APPARELS JB21 LTD

FS SFB #4, Road #2, Bay Area, CEPZ, Chattogram

31 October 2024

Observation-1: Prepared design report needs to be reviewed against lateral loadings. Building 1 (MAIN PRODUCTION BUILDING)

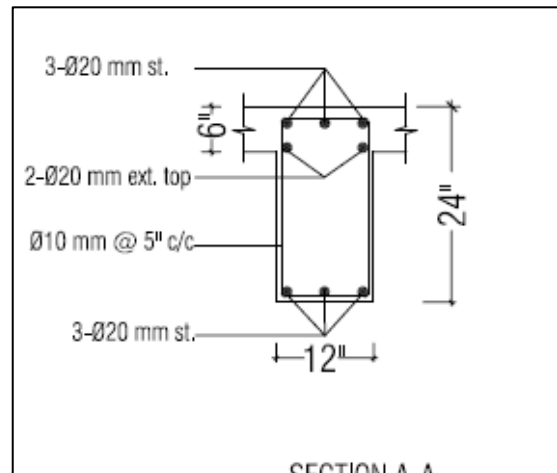
Design report, new core cutting, and extra braced bays

Description: During the inspection, a Detail Engineering Assessment (DEA) report was found onsite. New cores were taken to confirm the design strength. Additional braces are installed in the rooftop shed. Also, some discrepancies were observed in the structural member sizes. For portal frame steel framing response modification factor is considered as 8 without proper justification. However, the building engineer is required to revise the prepared DEA report based on as-built framing & member sizes. Submit the revised DEA documents to the RSC for detailed review against lateral forces.

Item No.	Observation	Action Plan	Timeline
1.	Prepared design report needs to be reviewed against lateral loadings. Building 1 (MAIN PRODUCTION BUILDING)	The building engineer is required to revise the prepared DEA report based on as-built framing system & member sizes. Submit the revised DEA documents to the RSC for detailed review against lateral forces.	within 6 weeks

Observation-2: Discrepancy in as-built drawing. Building 1 (MAIN PRODUCTION BUILDING)

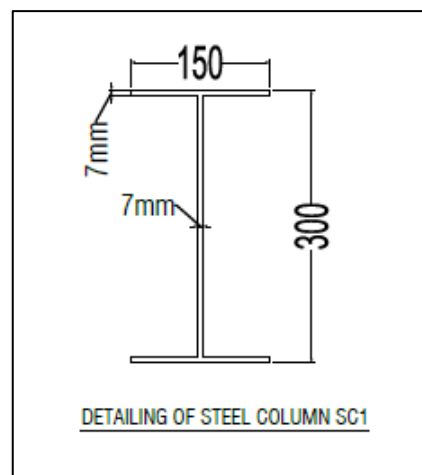
RB1 was measured as 350x475 mm which was shown as 300x475 mm in the drawing

Flange thickness of SC1 was measured 6 mm onsite where 7 mm shown in the drawing

Description: During the inspection, discrepancies and lack of information were observed between the provided drawing and on-site conditions. Floor beam RB1 was measured 350x475 mm which was shown 300x475 mm in drawing. Flange thickness of Steel column SC1 was measured 6 mm onsite which was shown as 7 mm in as-built drawing. Also, some drawings were incomplete. The building engineer is required to survey the whole structure and update the drawing reflecting on-site conditions.

2.		Carry out suggested remedial works if required.	within 6 months
3.		Continue to implement a proper load management plan.	within 6 months
4.	Discrepancy in as-built drawing. Building 1 (MAIN PRODUCTION BUILDING)	The building engineer is required to survey the whole structure and update the drawing reflecting on-site condition.	within 6 weeks

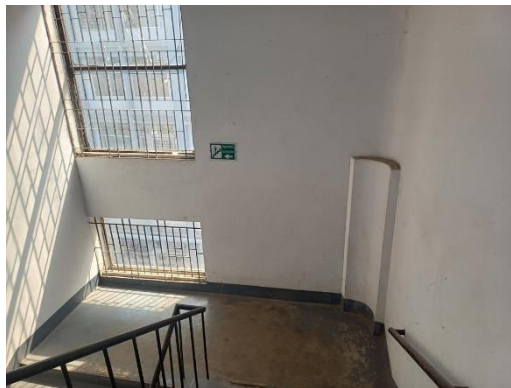
Extra bracing was observed in two bays

Retrofitting column didn't reach the proposed floor level

Structural details of the rooftop RO shed were not available
